B86485-02/-22

2nd Generation JIF-Share unit Release Notes

Document version: 2.04c

Release Date: December 4th, 2020

Enable 'Evolution Mode' and 'Switch on RDI' for VT's facing an Evolution Module

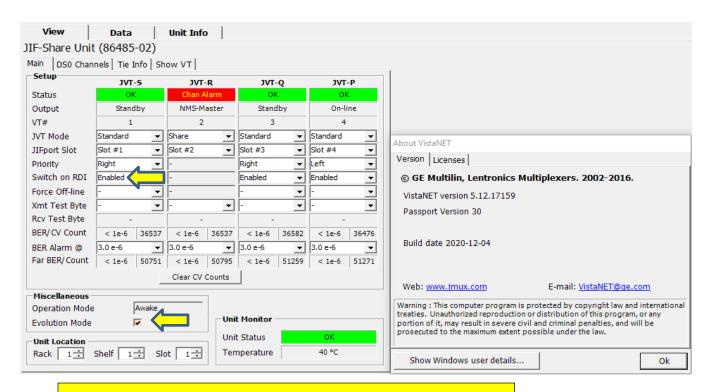
GE's new B86485-02 JIF-Share unit has been updated with new firmware to improve the signal integrity of VT's connecting via Evolution Modules (p/n B86900-01) to a JunglePAX 1G+ Hybrid Optical Transport port. JIF-Share units terminating VT1.5 from a JunglePAX network must be upgraded with this firmware to ensure reliable communications. Furthermore, for stitched conversion services (within the JunglePAX Tie node), the JMUX VT cards must use SOY to align the switching mechanisms across the network.

Customers shall enable "Evolution Mode" in the Main JIF-Share Unit's VistaNET GUI in both left and right cards at these locations.
